CATHOLIC CENTRAL NORTH CAMPUS JSP22-37

Public hearing at the request of Catholic Central High School for Planning Commission's approval of revised Special Land Use Permit, Preliminary Site Plan, Phasing Plan, Wetland Permit, Woodland Permit, and Stormwater Management Plan. The subject property is zoned R-4 One Family Residential, R-1 One Family Residential, and I-1 Light Industrial and is located in Section 18, west of Wixom Road and south of Twelve Mile Road. The applicant is proposing several new facilities in the northwestern portion of the Catholic Central High School campus: a 4-level parking structure (700 spaces), a hospitality/concession building, an athletic field for practices and competition, discus and shotput fields, and a new track and stadium.

PLAN REVIEW CENTER REPORT

Sheet Number: **L201**

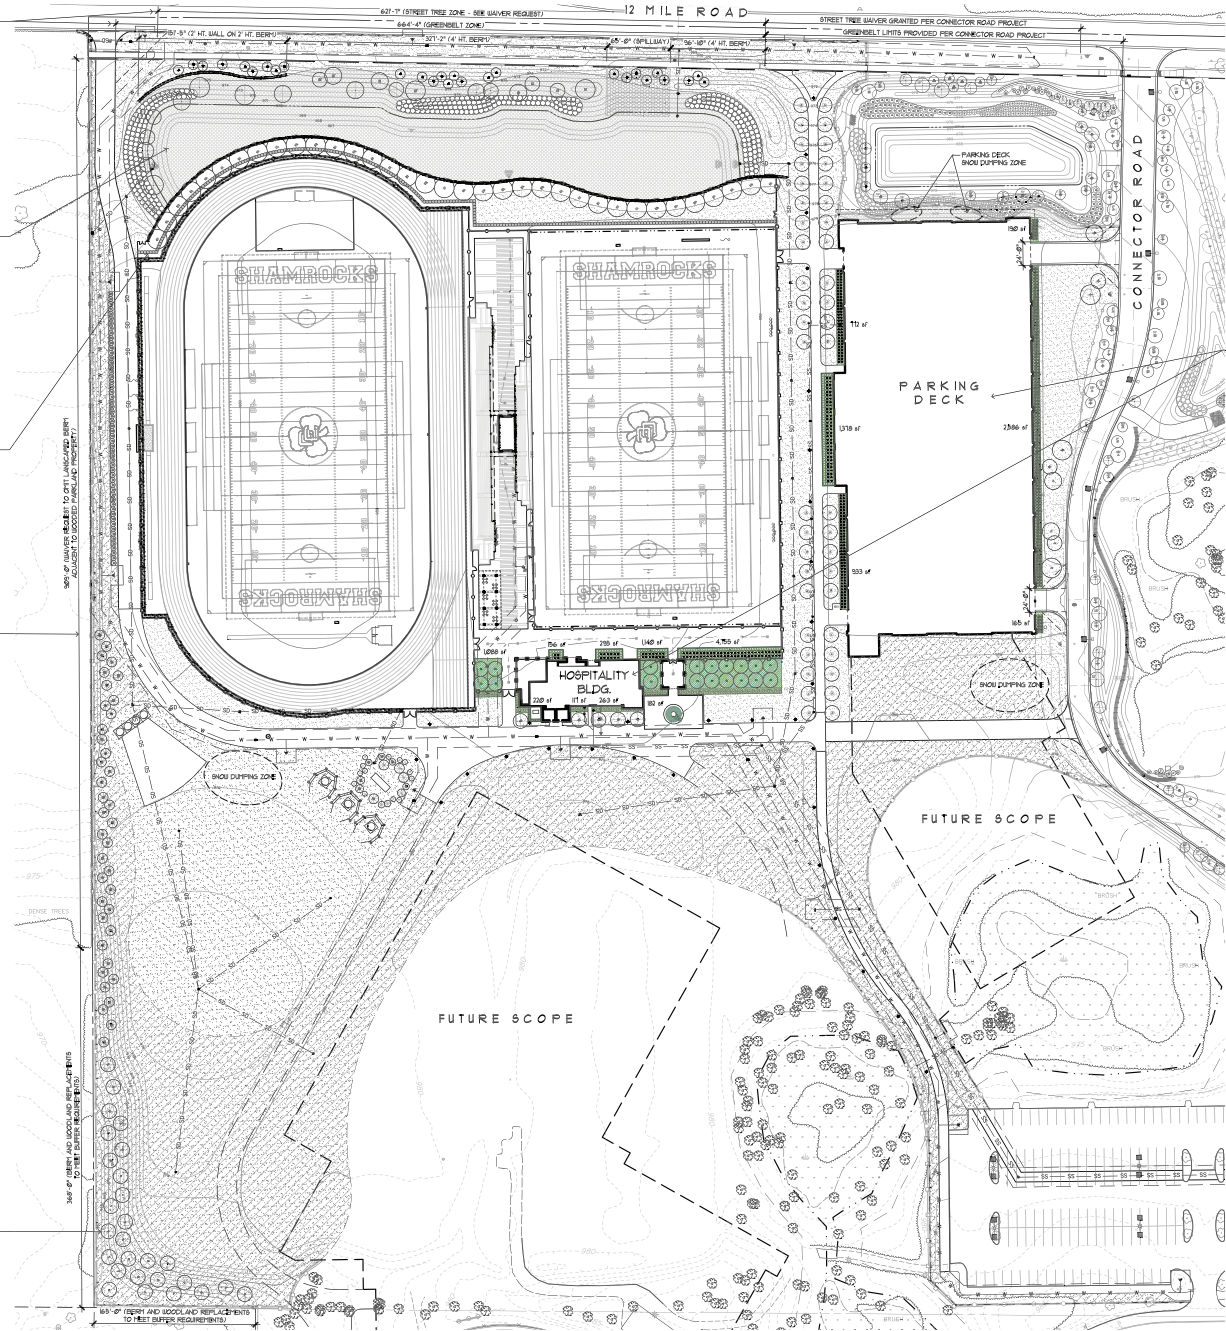
2. **Woodland Tree Removals (Sheet L201).** The Woodland Tree Removal List on sheet L201 shows both regulated woodland trees and non-regulated trees requiring mitigation - which is incorrect. Trees within city regulated woodlands, in the street right-of-way, and those that are 36" or greater in diameter at breast height (DBH) that are to be removed or whose critical root zone will be impacted by construction require mitigation (tree replacements). The applicant is encouraged to provide replacements for non-regulated trees that will be removed as they also provide a benefit to the site, however they should be listed separately from the tree replacements required for regulated trees. **Please revise applicable plan sheets to address comment.**

- i. To calculate the woodland fence inspection fees – **provide on Sheet L201 the cost to stake, install and remove the tree protection fencing**

Figure 2 | EGLE Wetlands Viewer Map. Approximate Site boundary is shown in red.

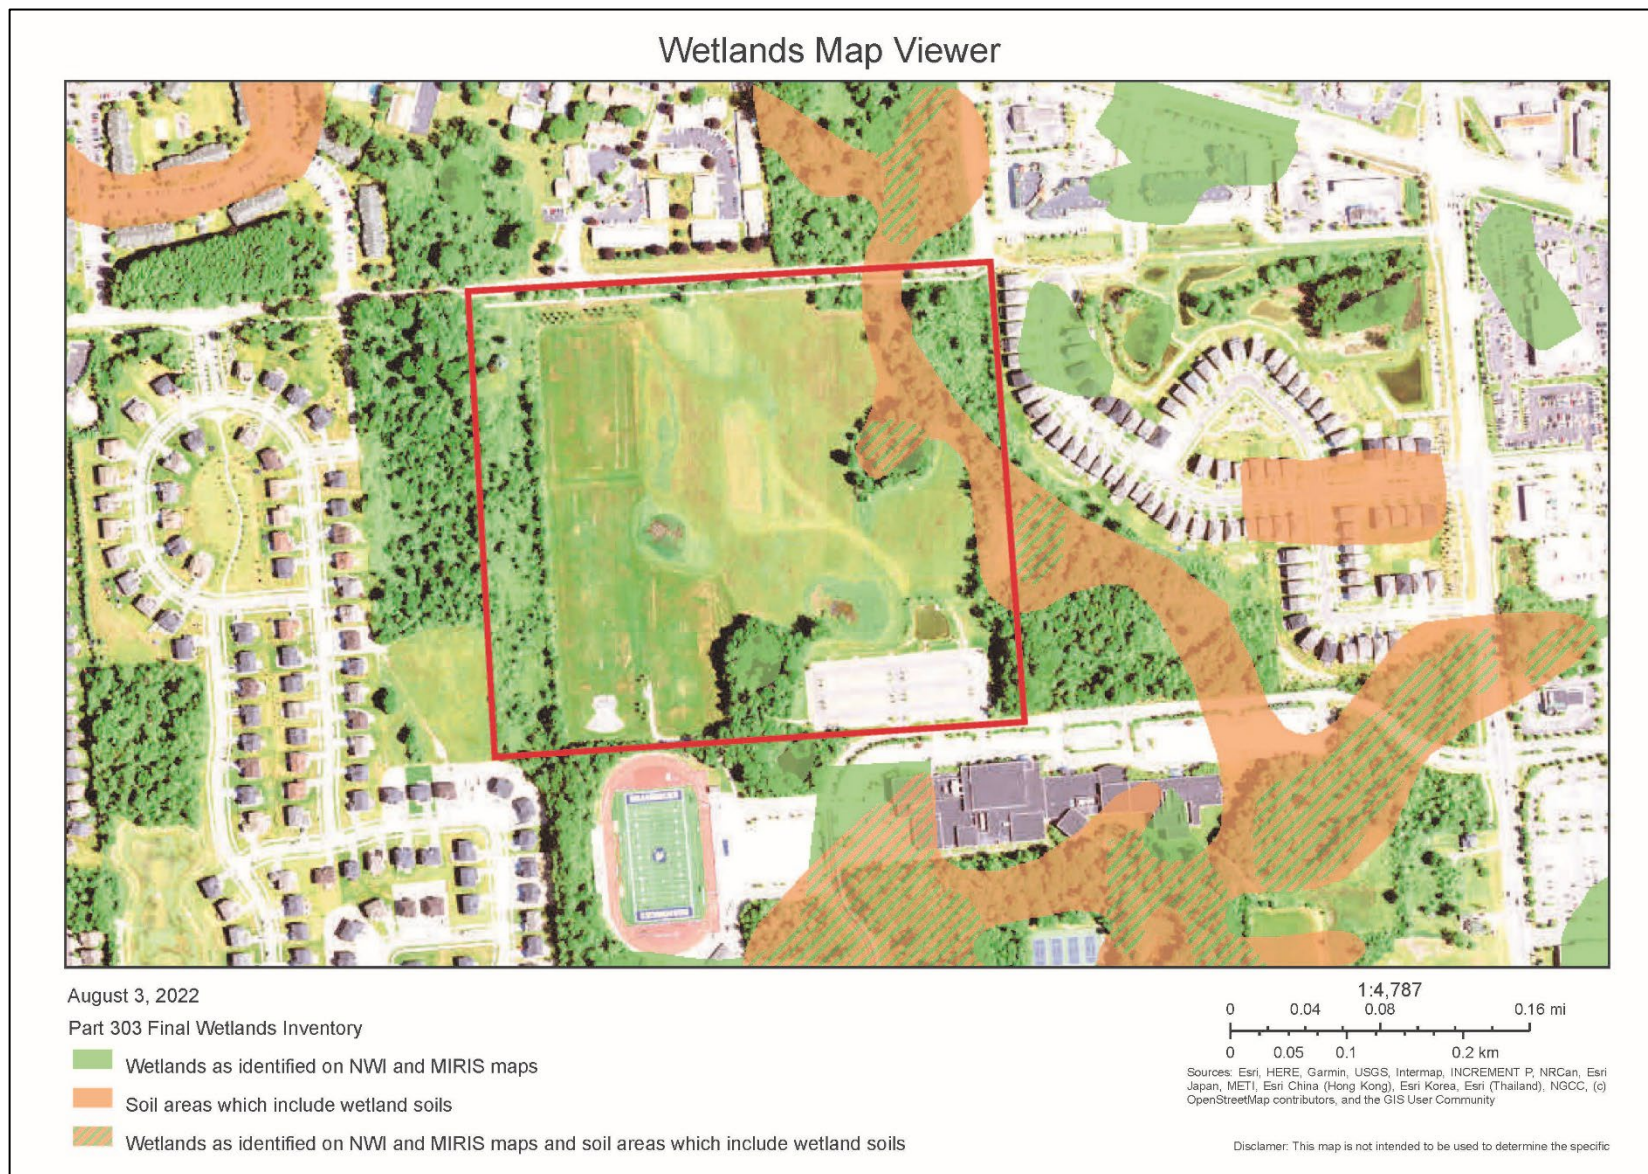
MSG concurs with the general depiction of Wetlands A through D in the rPSP. Portions of Wetland D and portions of the buffers of each of the four wetlands appeared to have been subjected to mowing. Sheet CE-9 of the rPSP states "*Phragmites australis* in entire Wetland D", but the area of *Phragmites australis* was observed to end abruptly and was surrounded by reed canary grass. Topographical depressions were also observed extending from Wetland D into regularly mown lawn grass areas, which suggests areas that are currently mown could support wetland habitat (Photo 7).
